Re: Monitoring, Reporting and Verification (MRV) Plan for Illinois Industrial Carbon Capture and Sequestration project (CCS #2)

Technical Review of Subpart RR MRV Plan for Archer Daniels Midland Illinois Industrial Carbon Capture and Storage Project

January 2017

Figure 2. Active Monitoring Area (AMA) consists of the AoR (green outline) shown above.

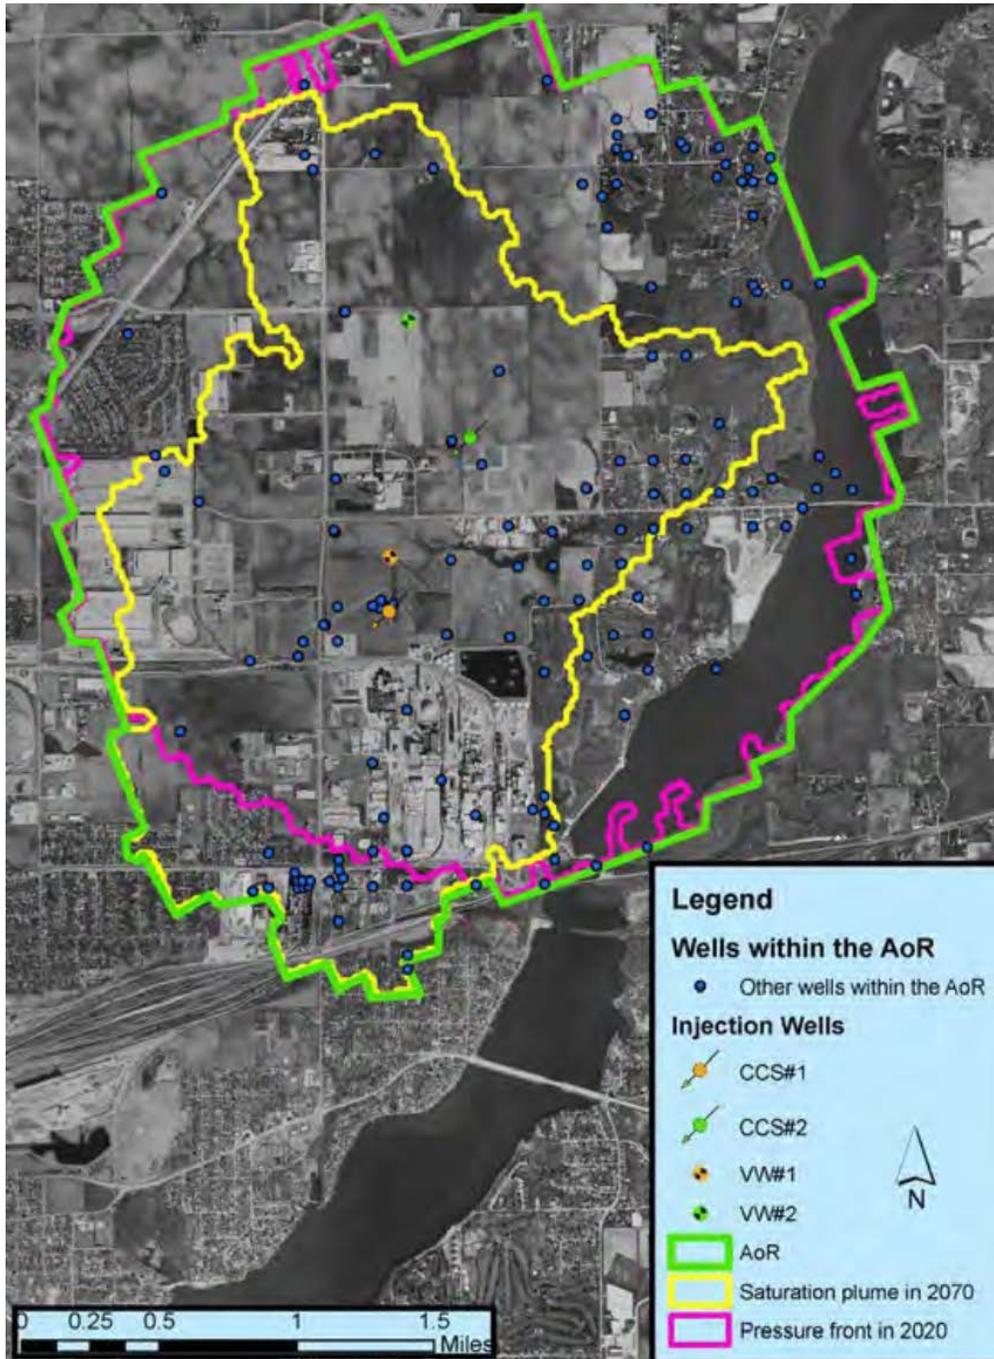
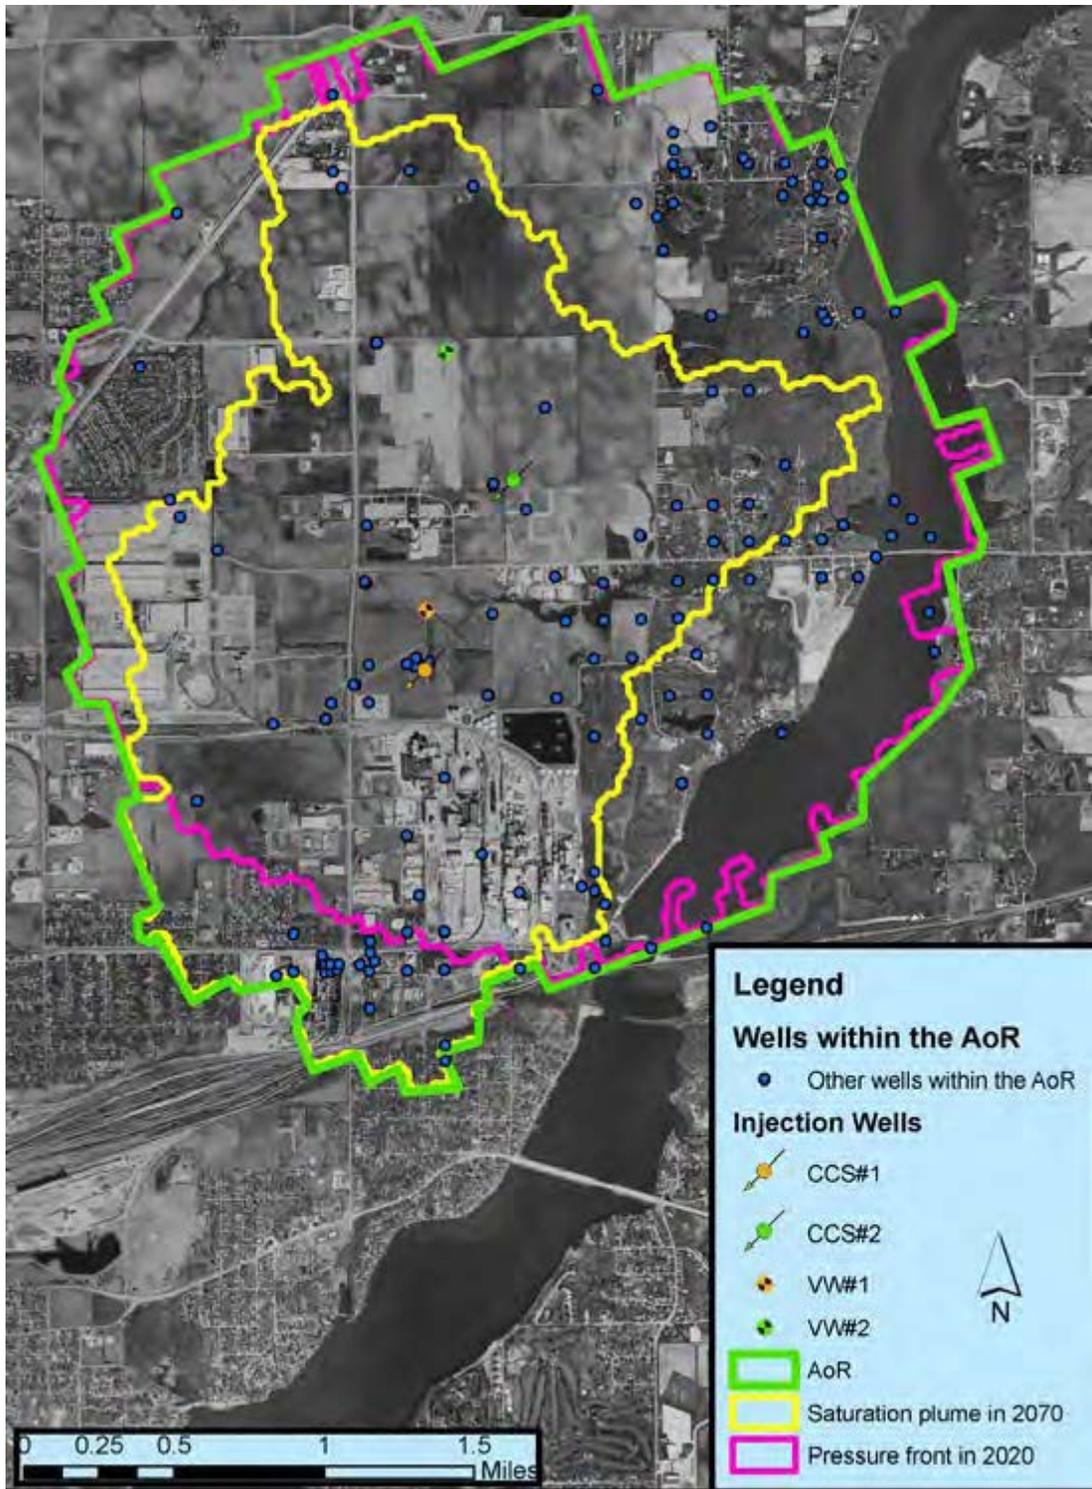
No.	MRV Plan		EPA Questions	Responses
	Section	Page		
2.	7. Delineation of Monitoring Areas	5	<p>MRV Plan: “For CCS#2, the AMA will remain constant throughout the 5-year injection period and the 10-year post-injection site care (PISC) period, and will consist of the AOR as shown in Attachment B of Reference 1. Figure 2 shows the extent of the AMA.”</p> <p>Please provide an updated version of Figure 2 (i.e., AMA) to reflect the AoR in the proposed permit modification.</p>	Updated the AOR figure 2.
